ADMINISTRATIVE AMENDMENT (FPA) ADD2015-00209

ADMINISTRATIVE AMENDMENT LEE COUNTY, FLORIDA

RE: *Miromar Lakes*
 Tract N-N, Positano
 Final Plan Approval
 HM Project No. 2014.099

Project: Positano at Miromar Lakes
Case: ADD2015-00209
STRAP: 12-46-25-00-00001.0010 & 13-46-25-00-00001.0020

FINAL PLAN APPROVAL SITE PLAN

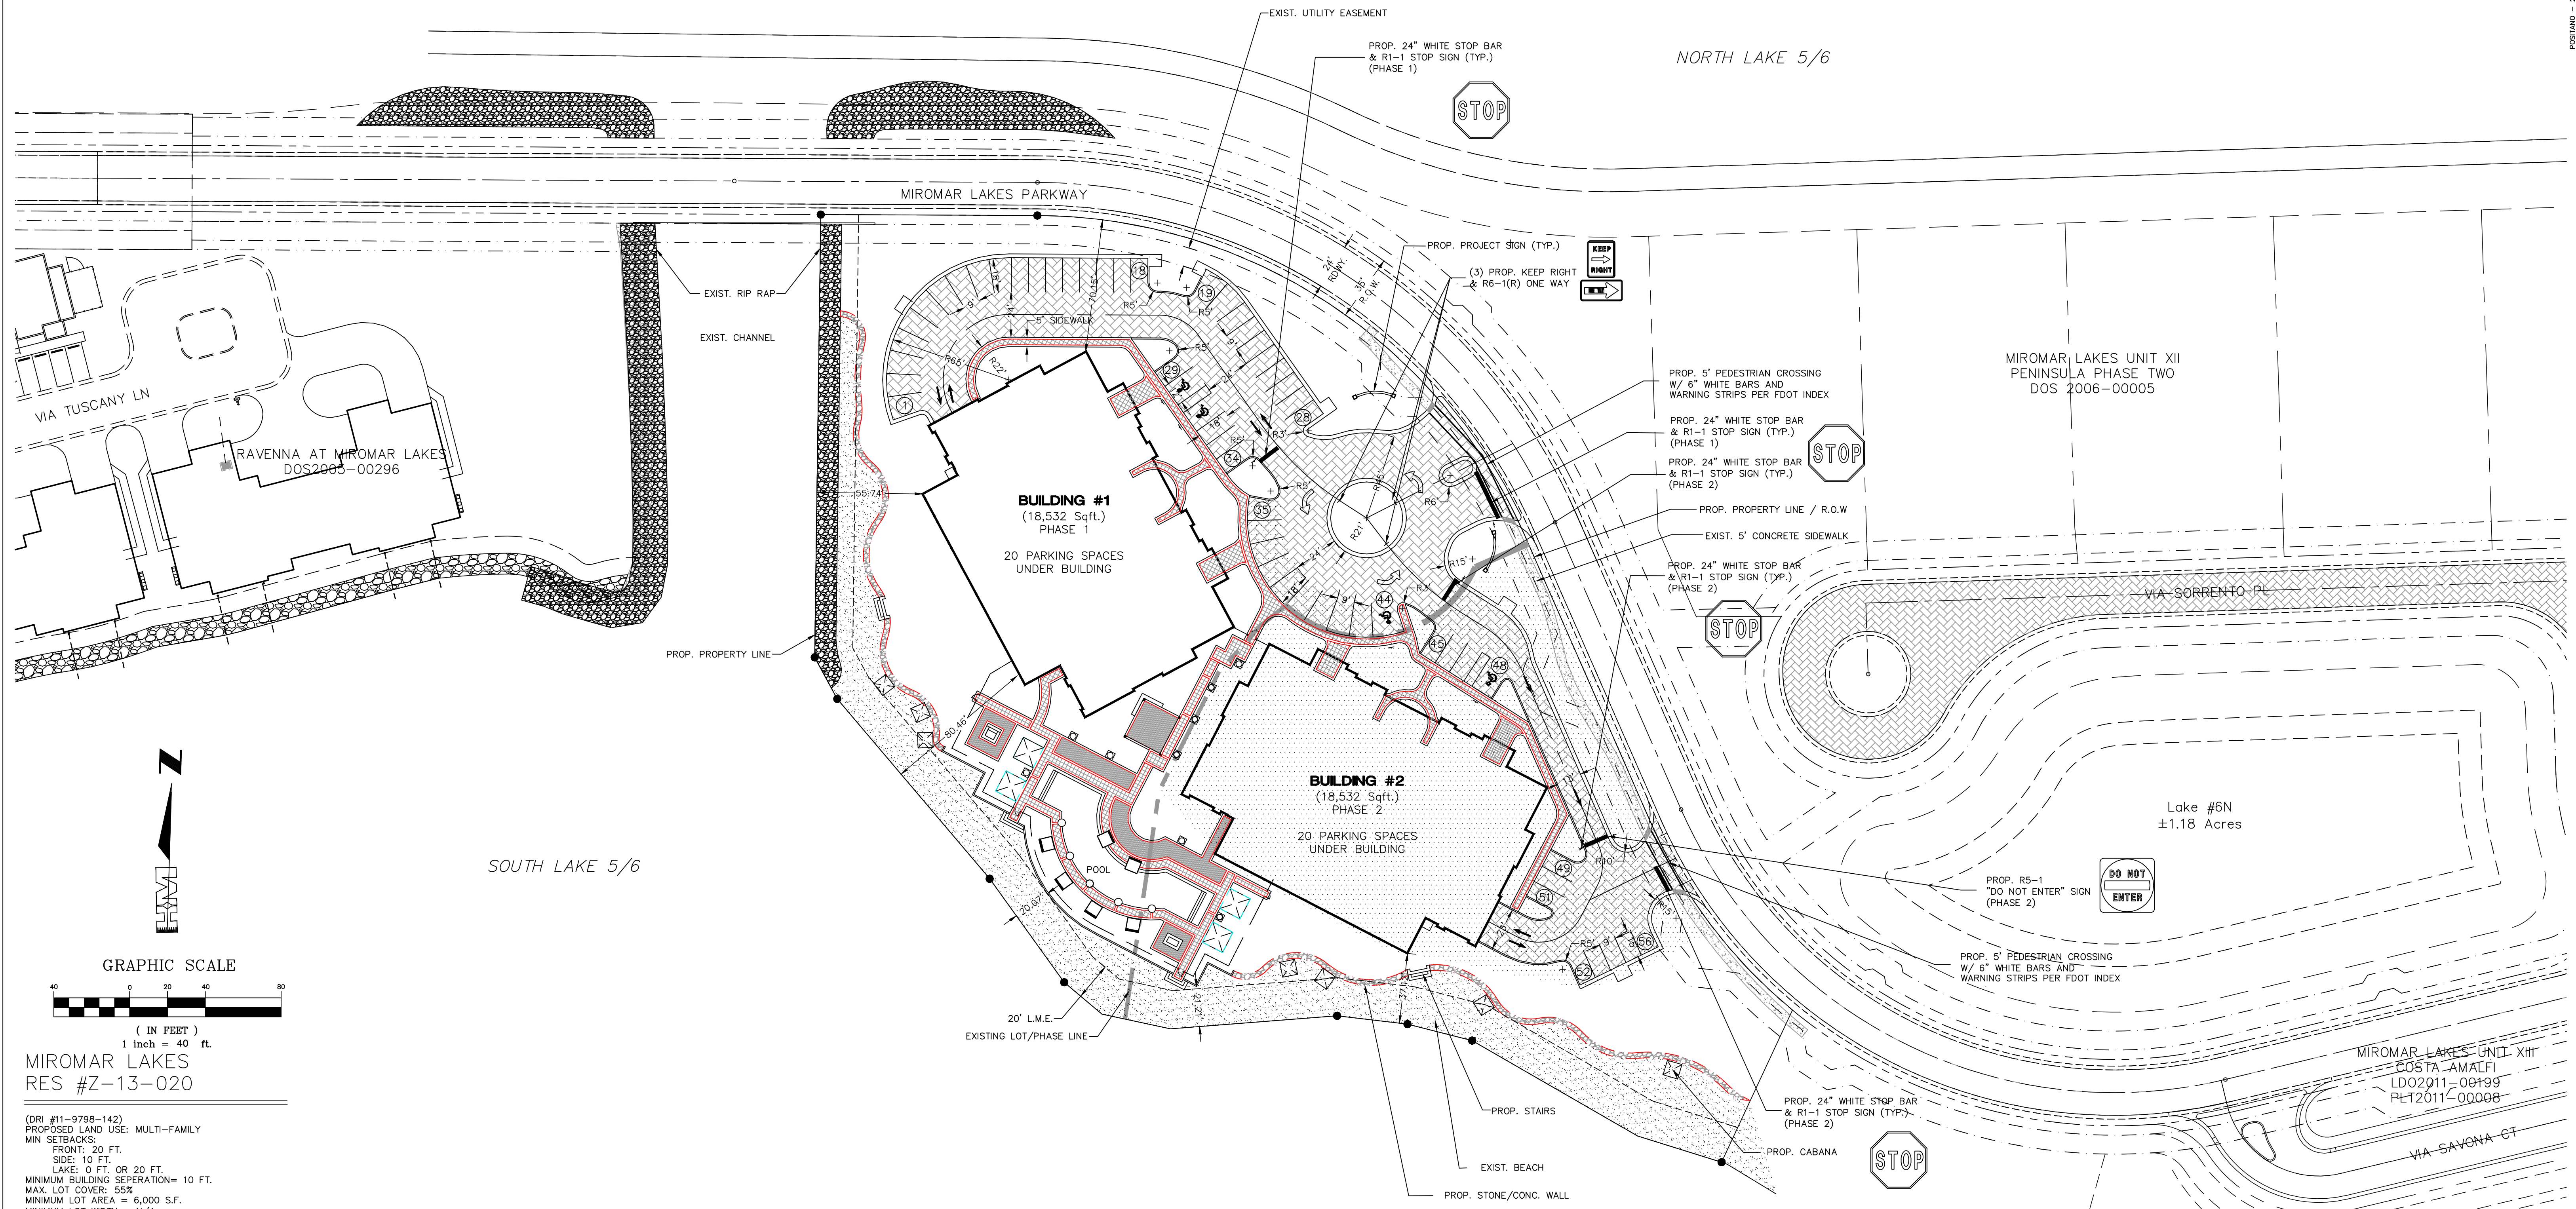
3. **Deviation #7 per Zoning Resolution Z-13-020 is approved with the following conditions:**
 - A. **The proposed stone/concrete wall must be removed from the lake maintenance easement prior to Development Order approval.**

- B. **A structural equivalency analysis for the pavers vs. asphalt must be submitted with the Development Order application.**
 - C. **The parking layout underneath the building must be provided with the Development Order application.**

Per condition 1d of the Z-13-020, the applicant has provided the required 40% open space on the MCP. There are no buffer or landscape strip requirements for this phase. The Limited Development Order must provide the required landscaping per Chapter 10-416 of the LDC.
